### Staff Report & Recommendation

### Design Review Board

SUBJECT: DRB18-0362  
**630 Alton Road, 650 Alton Road, 1220 6<sup>th</sup> Street, 659-737 West Avenue**

The applicant has submitted plans entitled "FINAL PB Submittal: Park Site" as prepared by **Arquitectonica**, dated signed and sealed March 11, 2019.

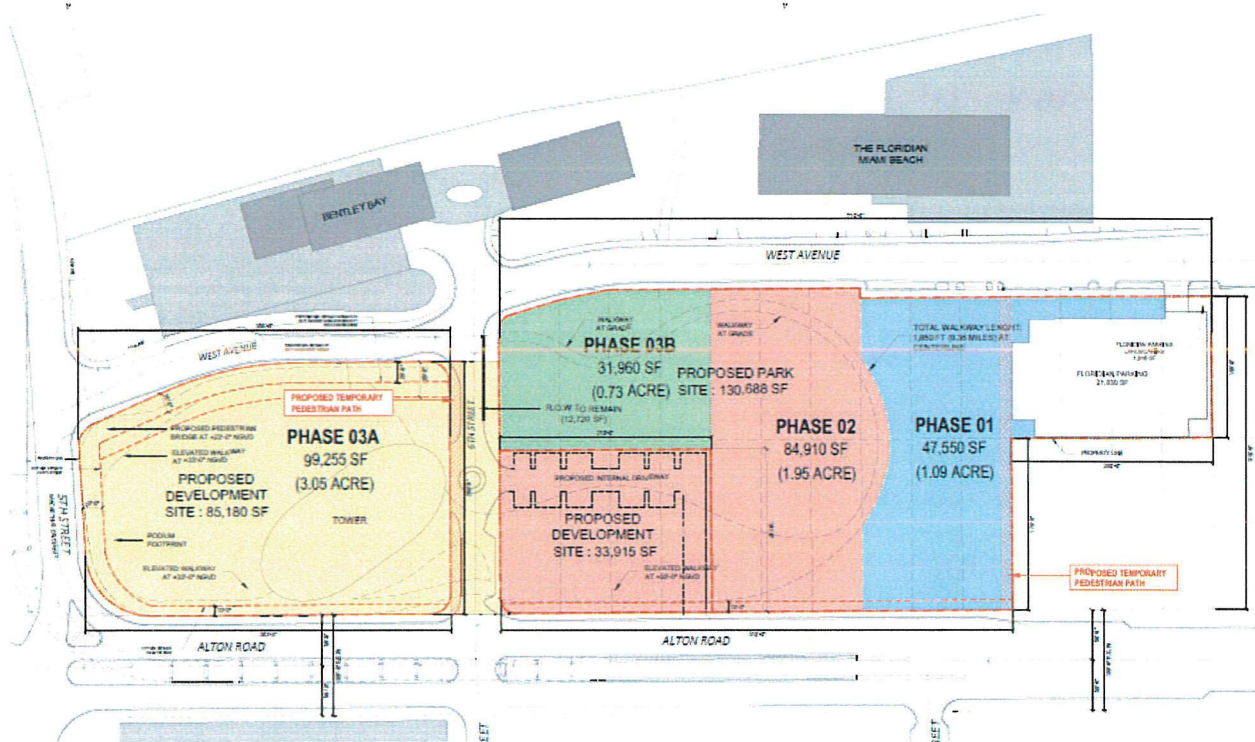
The site plan identifies the following areas (clockwise from north): surface parking area for Floridian condominium, a dog park, open lawn, and play scape area with splash pad featuring a signature thematic playground equipment, and an exercise Equilibria area.

Staff is highly supportive of the improvements proposed herein for the new park as they will greatly improve the quality of life for the immediate neighbors and visitors by improving pedestrian access to this gateway portion of the city, adding much-needed green space, and significantly transforming the site. The elevated walkway has been successfully integrated into the overall design, and is particularly advantageous in allowing elevated views of the park and crossing the site southward and potentially across 5<sup>th</sup> Street. Staff has worked very closely with the design team for the park and commends their efforts in the development of a very thorough set of design development drawings.
